**Cumberland County Subdivision and Land Development Review Report**

Plat Title: Joan and Edgar Coy

Plat Status: Final Plat Type: Subdivision

Date Received: 7/30/2020 County Review: 8/5/2020 Reviewed by: SH Checked by: \_\_\_\_\_

**FINAL SUBDIVISION PLAN FOR JOAN LOUISE BURNS COY AND EDGAR J. COY (PROPOSED LOT PLAN)**

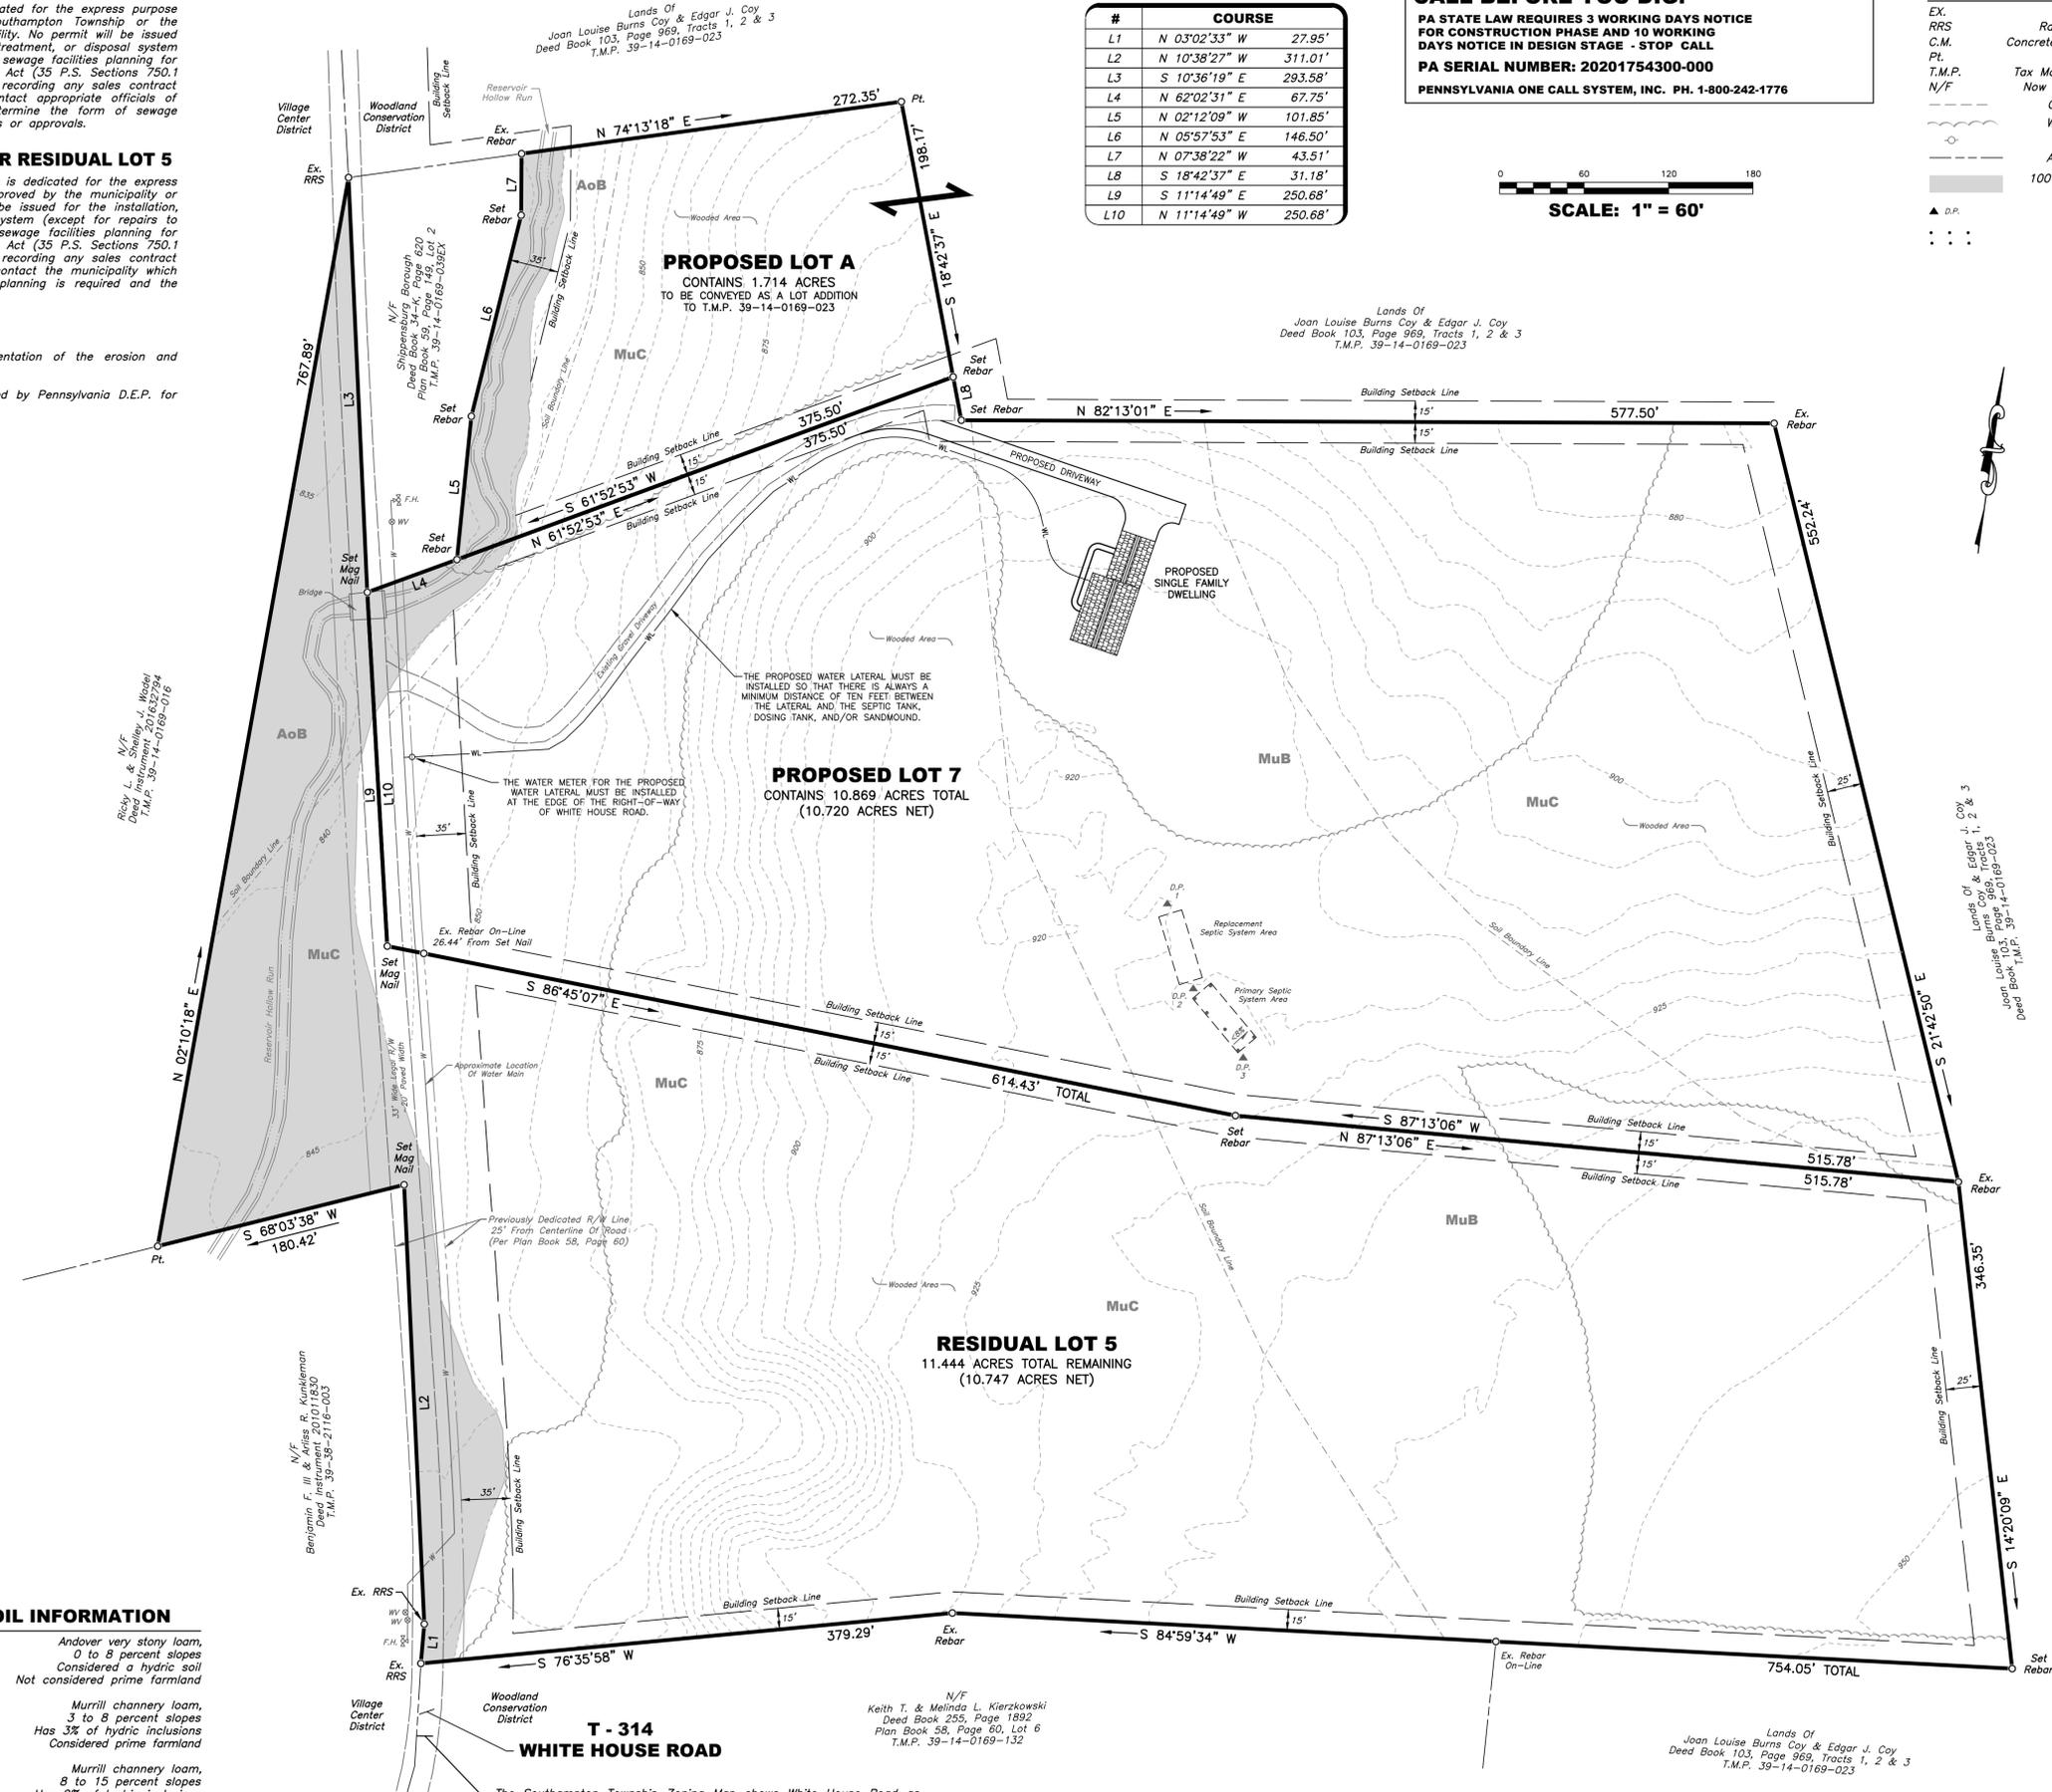
1. The proposed building height should be included in the Plan Information (Zoning 5.05.A).
2. The plan information indicates that proposed Lot B is a 1.714 acre lot addition. This lot is shown on the plan as proposed Lot A. The Applicant should clarify the plan (SLDO 305.1.F).

3. The Proposed Lot Plan Notes should include a Sewage Facilities Act approval code number from the Pennsylvania DEP (SLDO 305.2.F).
4. A Drainage Easement for Reservoir Hollow Run should be provided (SLDO 402.2).
